PLANT NAME: TURKEY PT # 3 & 4

ENCLOSURE
ANSWERS TO QUETIONS #'S 2 AND 3, AND REVISED ANSWERS TO QUESTIONS 8 AND 9 PERTAINING TO THE STEAM GENERATORS TUBE INTEGRITY SUPPLEMENTAL INFORMATION.....

Re: Turkey Point Units 3 and 4
Docket Nos. 50-250 and 50-251
Steam Generator Tube Integrity
Supplemental Information

FIGURE 2-1
RELATIVE WALL THICKNESS VS. ANGLE
ROWS 1, 2, 3

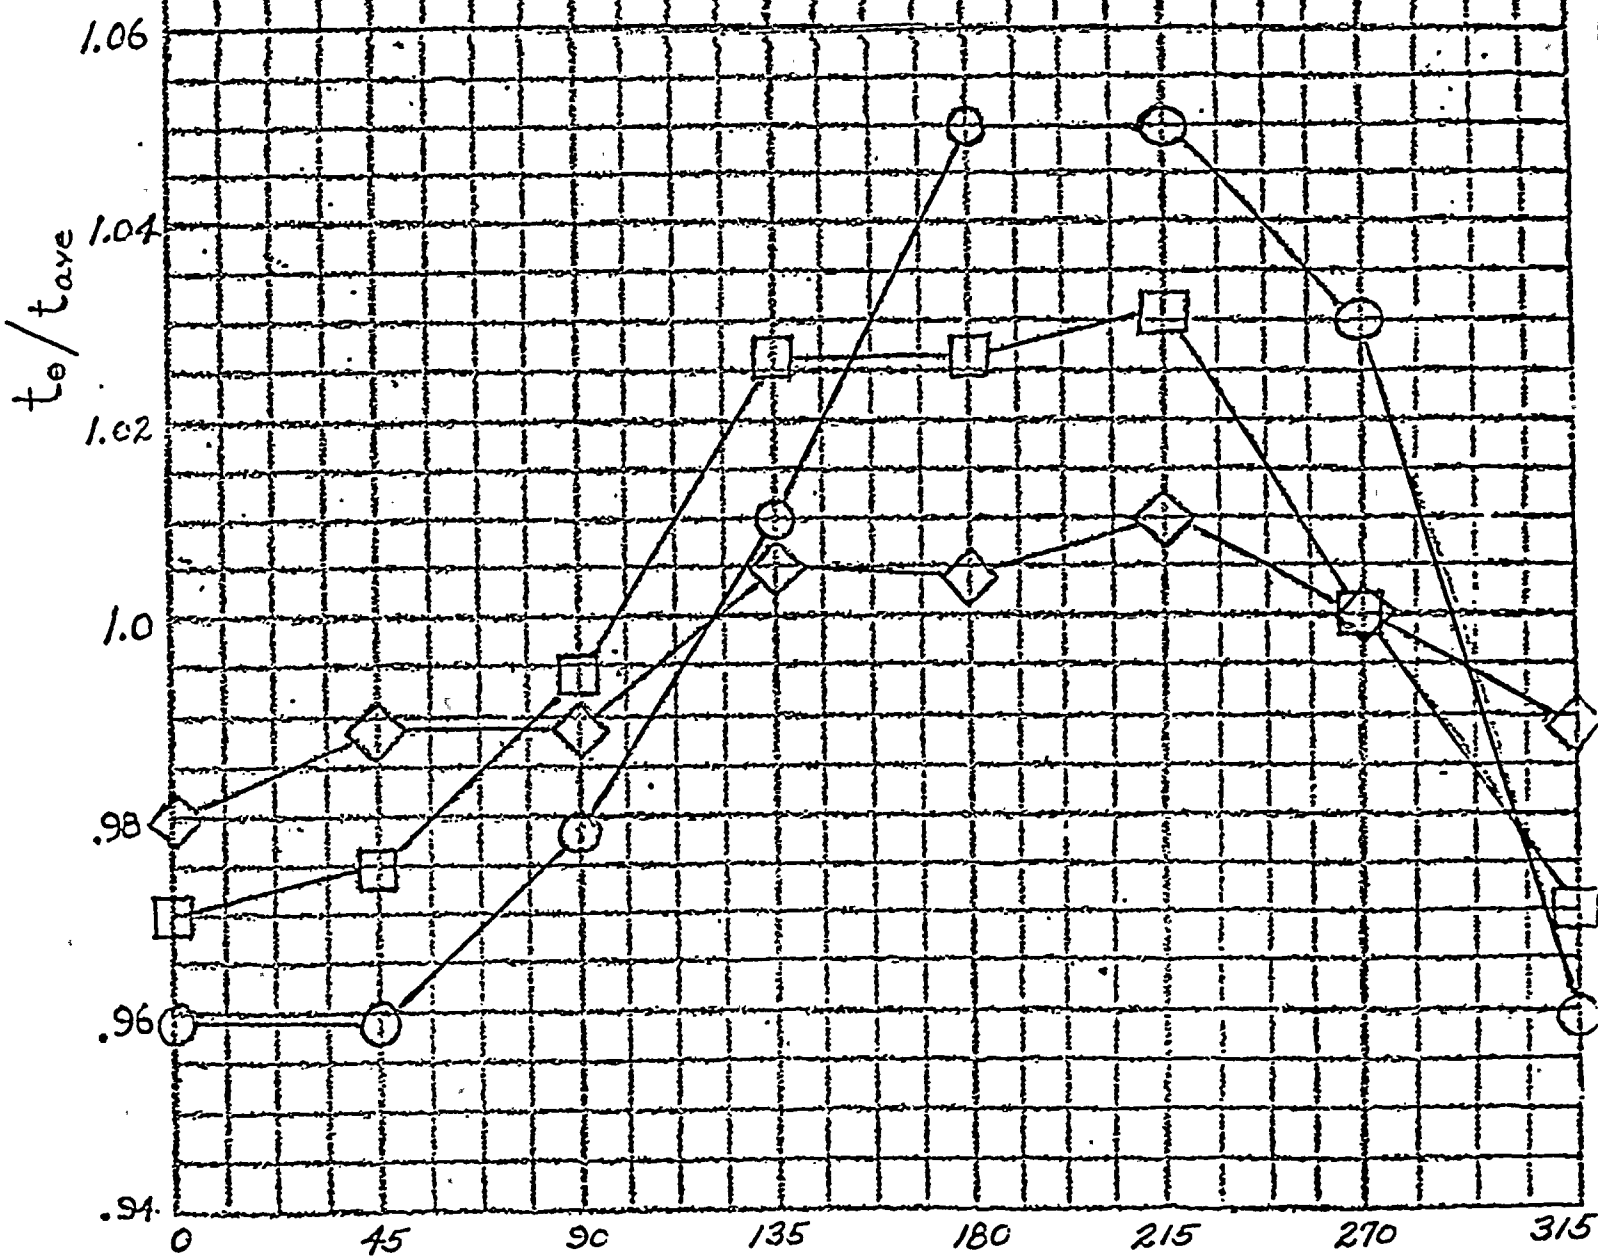
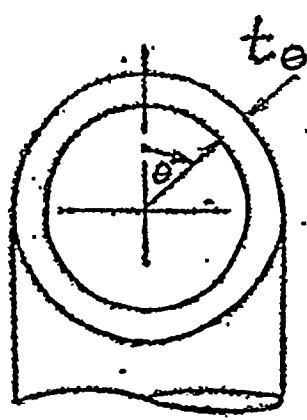
QUESTION #2 Estimate the error band and specify the degree of confidence in the strain data provided in response to question 1, i.e. specify the tolerances in the manufacturing strain.

3. Since the tube wall is always thinned at the extrados, the ratio of $t_{\theta}/t_{\text{ave}}$ taken from mill data (Figure 2-1) will be used in the strain tolerance calculations. From Figure 2-1 the tolerance on this quantity is less than $\pm .01$. Therefore,

$$\epsilon_{r \text{ max.}} = \frac{.95(t_{\text{ave}}) - t_{\text{ave}}}{t_{\text{ave}}} = -.050 \text{ in/in}$$

$$\epsilon_{r \text{ min.}} = \frac{.97(t_{\text{ave}}) - t_{\text{ave}}}{t_{\text{ave}}} = -.030 \text{ in/in}$$
